ADDENDUM NO. 1

VALPARAISO HIGH SCHOOL KITCHEN SERVERY RENOVATION AND RELATED WORK

ADDENDUM ONE

Addendum One (AD.01) to the drawings and specifications prepared by Gibraltar Design and The Skillman Corporation for **Valparaiso HS Kitchen Servery Renovation and Related Work** for Valparaiso School Corporation, Valparaiso, Indiana.

UNIT "E" PARTIAL
SECOND FLOOR FINISH PLAN

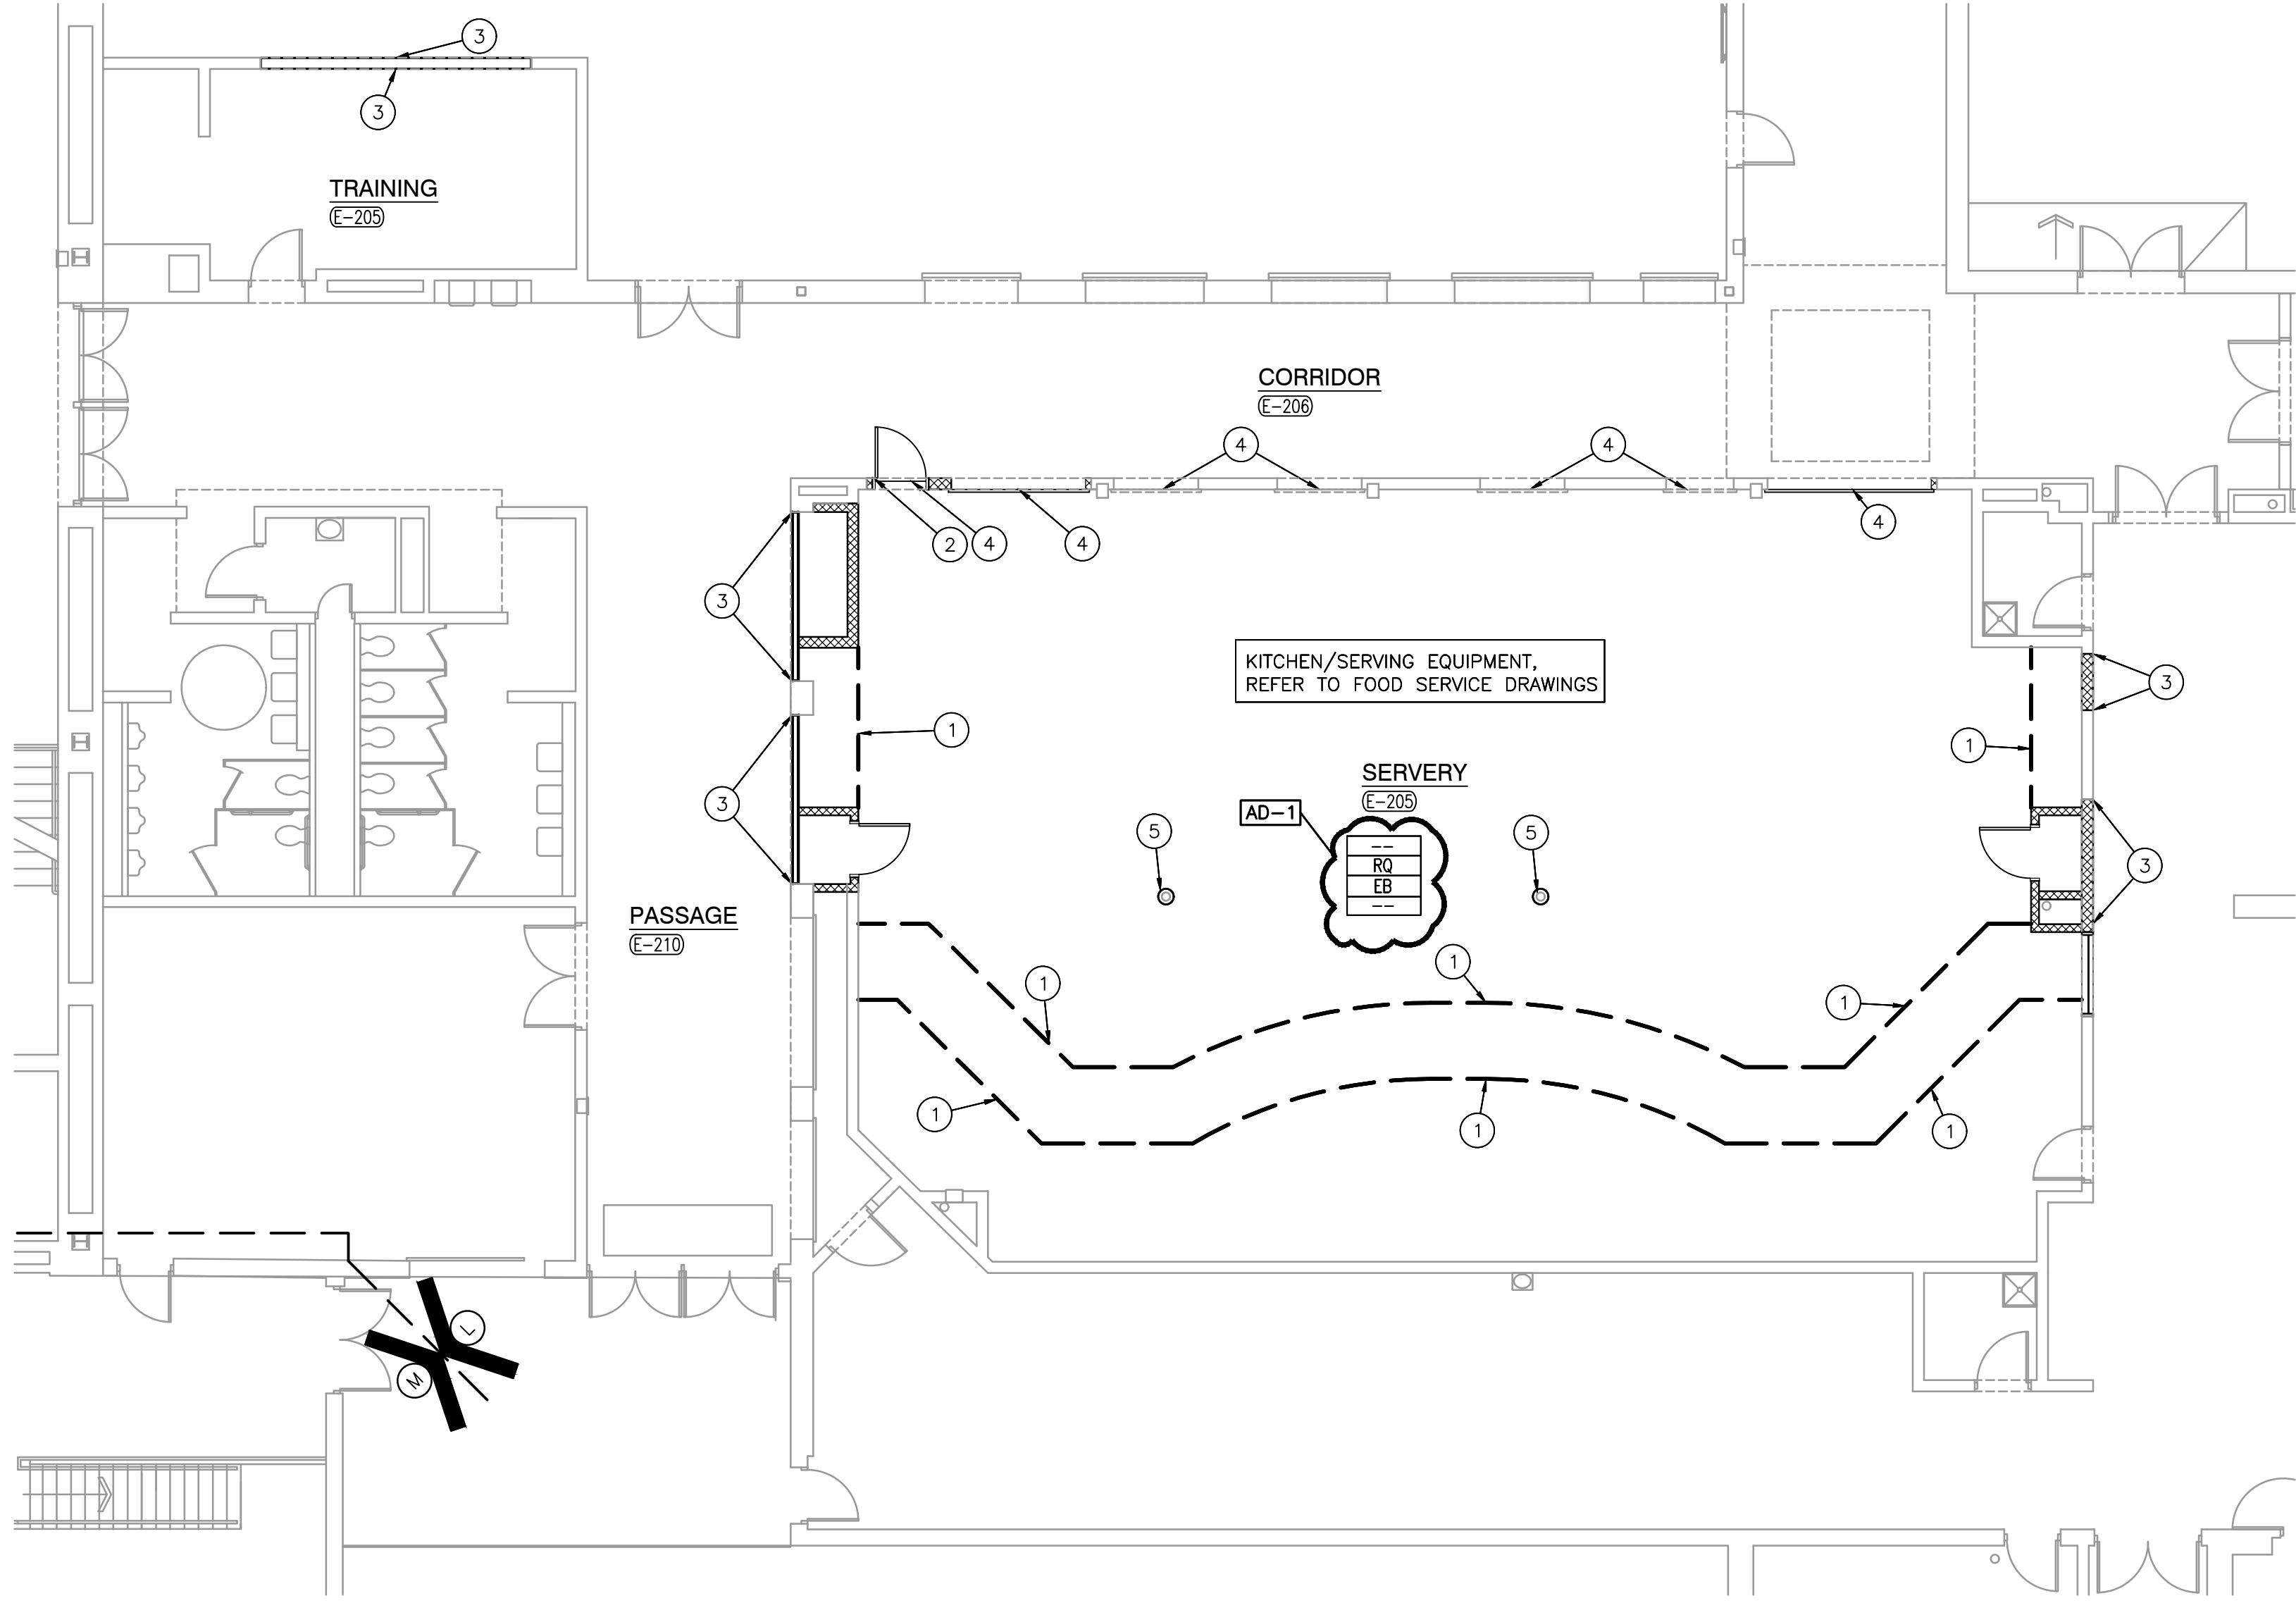
2. Sheet A-102

1. Unit "E" Partial Architectural Second Floor Demo Plan: Revise finish symbol in Servery E-205.
